**Distribution****Unit Managers' Meeting: 300 Areas Remedial Action Unit/Source Operable Units****0057893**

Meeting Minutes Transmittal/Approval  
300 Area Unit Managers' Meeting  
Remedial Action and Waste Disposal Unit/Source Operable Unit  
3350 George Washington Way, Richland, Washington  
May 2002

**Comment Response Package  
To Technical Expert Review  
On the Preliminary Results from the Kd/Leach Study of 2001  
and the Draft Uranium Conceptual Site Model White Paper**

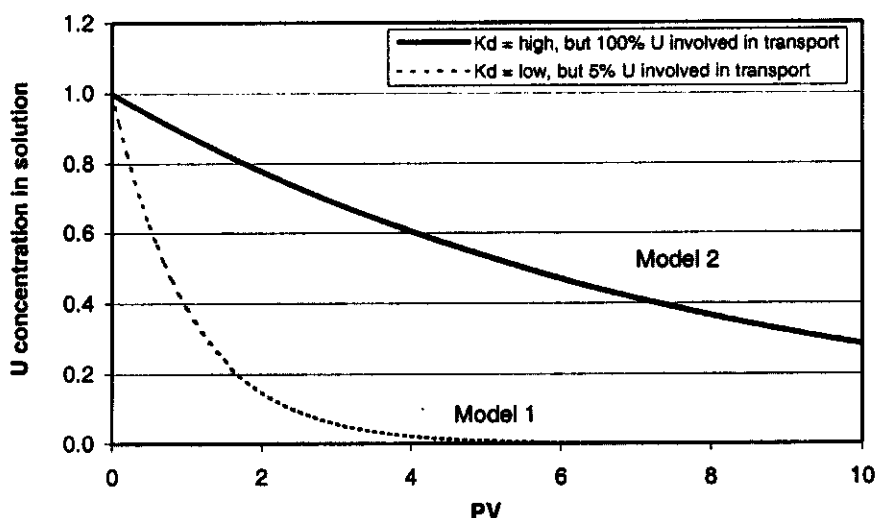
The plan proposed here for applying the FY01 results to the area 300 RESRAD modeling does not accurately describe the mechanisms of transport. The experimental work shows that there is a relatively small fraction of uranium (< several percent) that is very easily leached from the soil. The remaining material is very tightly bound. This is not amenable to a simple  $K_d$  model. Using a desorption  $K_d$  that is calculated by using the maximum concentration in the leach solutions, and the total uranium present in the soil, will yield a relatively large  $K_d$ —but using this as described in the White Paper is incredibly conservative. If contaminants are being leached from a soil and the  $K_d$  is large, then most of the uranium is in the solid phase, and the concentration in solution drops only very slowly with time. If the initial solution concentration is assumed to be high (as in the leach column experiments), then it will remain high for a very long time.

I have included an illustration of this in Figure 1. Two conceptual models are shown here. In the first model, 5% of the uranium in the system is assumed to be highly mobile (the  $K_d$  is low, 0.1), and the other 95% is assumed to be immobile (this is similar to what the experimental data suggest). The concentration in solution drops very quickly, as the majority of the exchangeable U, at any step, is in the solution. In the second model, 100% of the uranium was involved in sorption, and a moderate  $K_d$  (7) was used (this is essentially what is being proposed for the site 300 RESRAD model). The concentration in solution in this case drops much more slowly. The only constraint on these two models is that the initial concentration in solution is the same. For the site 300 case, it would be the maximum U concentration in the leachate from Jeff Serne's column experiments. It's obvious that using a higher  $K_d$ , but assuming that more of the uranium participates in sorption, is very conservative.

The draft white paper (Attachment A) was revised to reflect the more appropriate  $K_d$  process that was described above. As recommended, the proposed conceptual site model (CSM) will differentiate from the readily leachable, the more tightly bound (less leachable), and the saturated zones uranium. The basis/rationale for proposing this CSM is also provided in the draft white paper.

The PowerPoint presentations were also revised to align with the changes made to the white paper as described above.

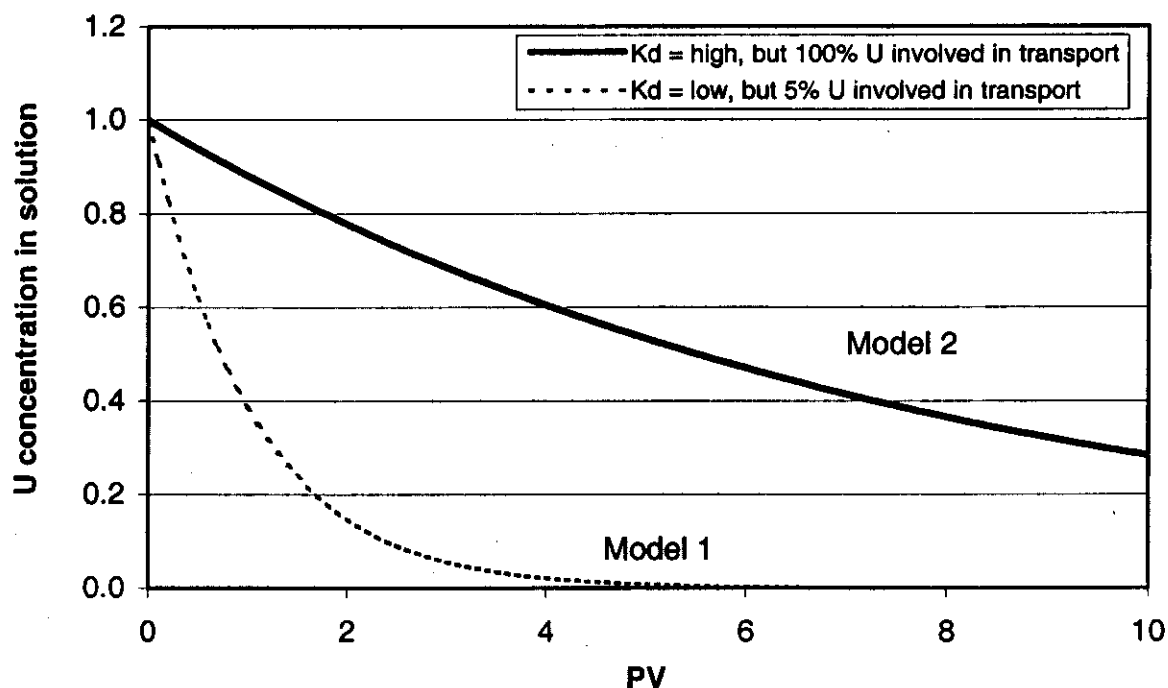
Also, the justification for using the different Kd's must be more rigorously defended. The plan proposed here for applying the FY01 results to the area 300 RESRAD modeling does not accurately describe the mechanisms of transport. The experimental work shows that there is a relatively small fraction of uranium (< several percent) that is very easily leached from the soil. The remaining material is very tightly bound. This is not amenable to a simple Kd model. Using a desorption Kd that is calculated by using the maximum concentration in the leach solutions, and the total uranium present in the soil, will yield a relatively large Kd—but using this as described in the White Paper is incredibly conservative. If contaminants are being leached from a soil and the Kd is large, then most of the uranium is in the solid phase, and the concentration in solution drops only very slowly with time. If the initial solution concentration is assumed to be high (as in the leach column experiments), then it will remain high for a very long time.

I have included an illustration of this in Figure 1. Two conceptual models are shown here. In the first model, 5% of the uranium in the system is assumed to be highly mobile (the  $K_d$  is low, 0.1), and the other 95% is assumed to be immobile (this is similar to what the experimental data suggest). The concentration in solution drops very quickly, as the majority of the exchangeable U, at any step, is in the solution. In the second model, 100% of the uranium was involved in sorption, and a moderate  $K_d$  (7) was used (this is essentially what is being proposed for the site 300 RESRAD model). The concentration in solution in this case drops much more slowly. The only constraint on these two models is that the initial concentration in solution is the same. For

the site 300 case, it would be the maximum U concentration in the leachate from Jeff Serne's column experiments. It's obvious that using a higher  $K_d$ , but assuming that more of the uranium participates in sorption, is very conservative.

If the model is conservative, is it valid to use it for the Site 300 remediation studies? Maybe—but further work is really necessary to show that the model is conservative. Since the mechanisms of uranium release and transport are not known, it may be that the proposed model, based on lab experiments to date, is sensitive to variables not yet examined. Jeff's proposals to try and determine the actual form of the uranium in the soil, and to examine the effects of

**General Response:** The path forward recommendation as presented below was appropriately incorporated in the revised draft white paper (Attachment A) and, additionally, the controlled Kd/leach laboratory study (Attachment B) was optimized based on the evaluation of laboratory results from work performed in 2001 and from the recommendations.
